# Environmental and Ecological Planning Advisory Committee

## Report

The 1st Meeting of the Environmental and Ecological Planning Advisory Committee  
December 16, 2021

## Wetlands

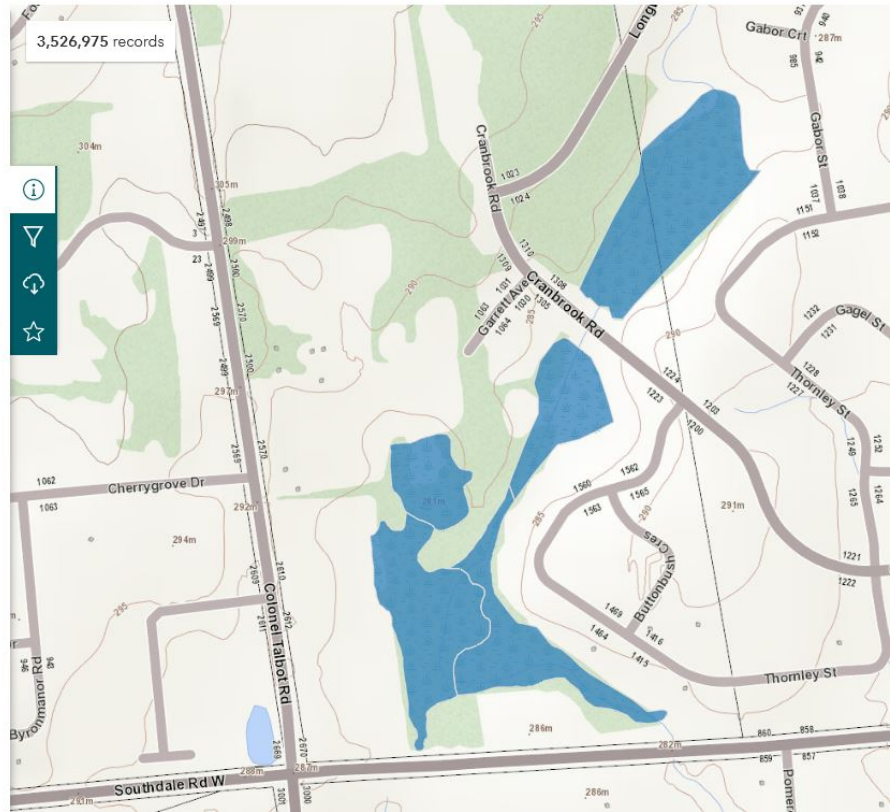
8. The entire PSW is not shown in the air photo figures which is annoying at best and understates the significance of the feature.
9. The full extent of the PSW is noted on Ontario GeoHub (see appendix) and Map 5 of the London Plan. It should be clear to everyone the extent of the PSW.
